APPLICATION NO.	FILING DATE	FIRST NAMED INVENTOR	ATTORNEY DOCKET NO.	CONFIRMATION NO.
09/172,553	10/14/1998	JAMES E. GREEN	2914.IUS	9441

Office Action Summary

DETAILED ACTION

Fig. 9

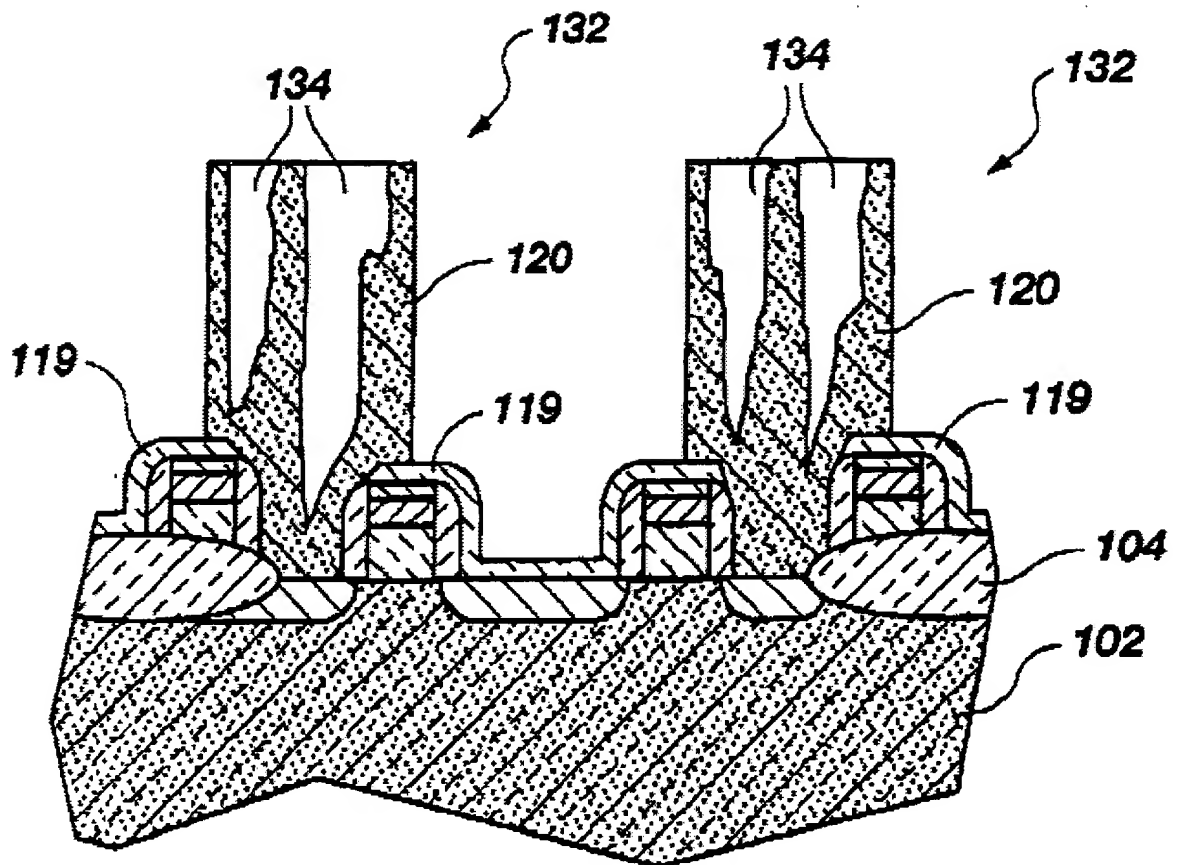
6. Regarding claims 31, 33, 35 and 40 the terms "contiguous mesas" and "contiguous webs" renders the claim indefinite because it is not clear the boundary of the claimed mesas or webs. Please clarify the following:

a) With regards to figure 9, what portion of the storage poly 120 constitutes a mesa or web? Also, which portions of the storage poly 120 constitute the top and bottom portions of the mesa or web? In addition, how the depth of the opening or recess 134 is related to the height of the mesa or web? And, please identify at least two contiguous mesas.

Fig. 22

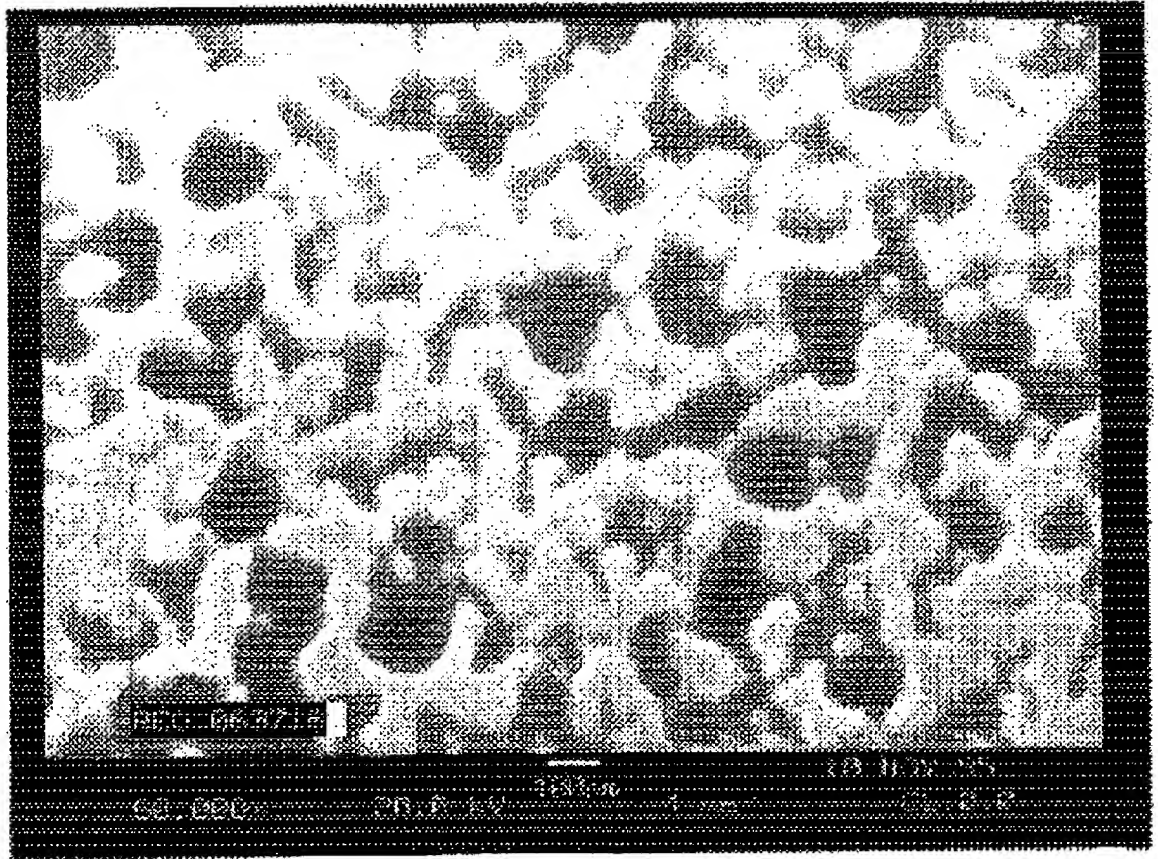
b) With regards to figure 22 (top view), please identify at least two mesas. Also, identify the start and end points of each mesa. And, please identify at least two contiguous mesas.

Fig . 10

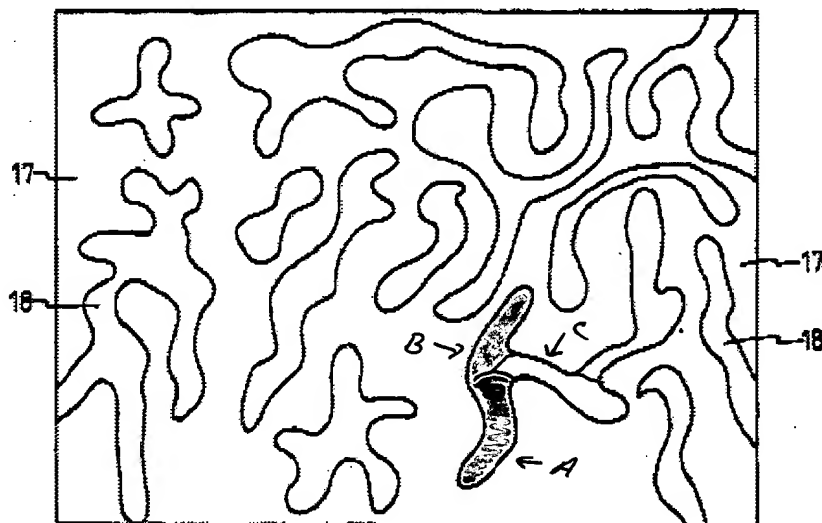
Regarding claims 31-32, Woo et al. teach a semiconductor capacitor storage poly (30) (see figure 2) comprising: downwardly extending recesses (consider the space between the mesas 23 in fig. 2); and a plurality of *contiguous mesas* (23) extending in the X, Y and Z coordinates (see figure 2) and comprising a plurality of contiguous top surfaces (18) (see fig. 10) forming a maze-like structure (see the passages between the mesas 23 in figures 2 or the passages 17 between the top surfaces 18 in fig. 10).

With regards to the terms "contiguous mesas" or "contiguous webs", please refer to figure 10, below, in which mesas or webs A, B and C are shown connected to one another.

F I G . 4 c

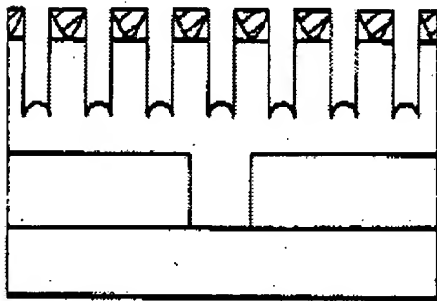
Regarding claims 35 and 43, Jun et al. teaches an intermediate semiconductor capacitor structure (see figure 4c) comprising: a storage poly structure (13) comprising a plurality of contiguous mesas (consider the fingers or columns that include mask 15 and HSG 14 in fig 4c) with recess formed therein (consider the space between the fingers or columns in fig. 4c); a contiguous hemispherical-grain polysilicon (14) over said storage poly structure (13) (see fig. 4c) and a mask (15) over said hemispherical-grain polysilicon layer (14), said recesses (consider the space between the fingers or columns) being exposed through said contiguous hemispherical-grain polysilicon (14) and said mask (15) (see figure 4c).

With regards to the terms "contiguous mesas" or "contiguous webs", please refer to figures 4c and 6c, below. Please note that figure 4c shows shallow recesses that do

not disturb the continuity of the storage poly structure 13. Thus, figure 4c shows storage poly fingers connected throughout in an unbroken sequence.

F I G . 6 c

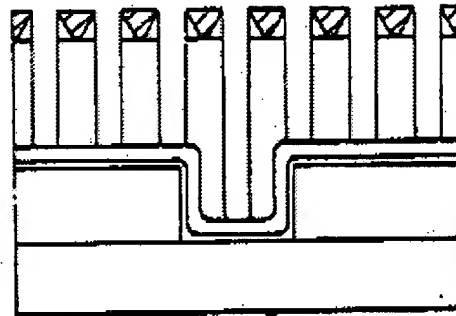
By the contrary, figure 6C shows deep recesses that disturb the continuity of the fingers. Thus, in this case figure 6c does not show contiguous fingers. Therefore, the terms "contiguous mesas" or "contiguous webs" in view of Jun et al. will be define according to figure 4c, in which shallow recesses are provided without disturbing the continuity of the storage poly.
